HL-5411

Edwin I. Hatch Nuclear Plant  
Response to Request for Additional Information on  
Spent Fuel Pool Regulatory Analysis

Edwin I. Hatch Nuclear Plant  
Response to Request for Additional Information on  
Spent Fuel Pool Regulatory Analysis

Dose Rate on Refueling Floor vs. Pool Water Depth Figure

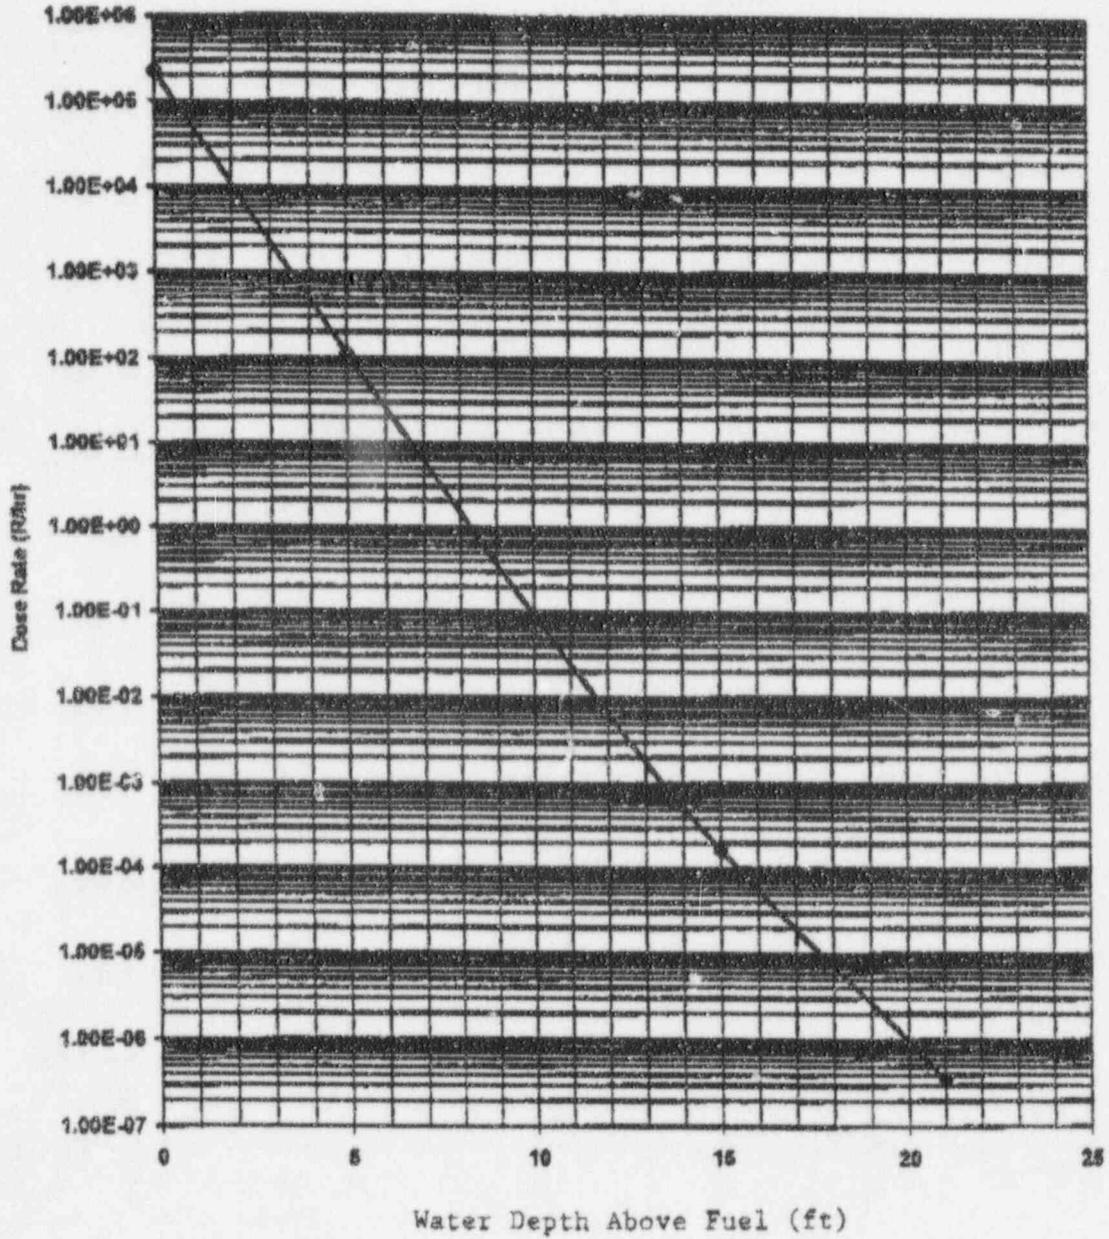
Will the spent fuel pool (SFP) boiling produce high radiation levels on the refueling floor (RF) before significant inventory boil-off? If so, what is the expected source of high radiation levels on the RF during a boiling event (prior to any significant lowering of pool level), and what radiation levels do you expect at various points during a pool boiling event (in mr/hr)?

The dose rates on the refueling floor following a pool boiling event, without makeup water, are presented in the attached figure. The dose rates were calculated assuming a full-core offload with 150 hours decay. The dose rates, which range from  $3.6E-4$  mR/hour with 21 ft of water to  $2.3E8$  with no water above the spent fuel, are essentially at elevation 228 ft, in the line of sight of the pool. Dose rates away from the pool will obviously be less than those provided in the attached figure.

As shown in the figure, significant radiation levels on the refueling floor are not reached until water level decreases to approximately 10 ft above the fuel. Therefore, fuel pool boiling will not produce high radiation levels on the refueling floor before significant pool boiloff occurs.
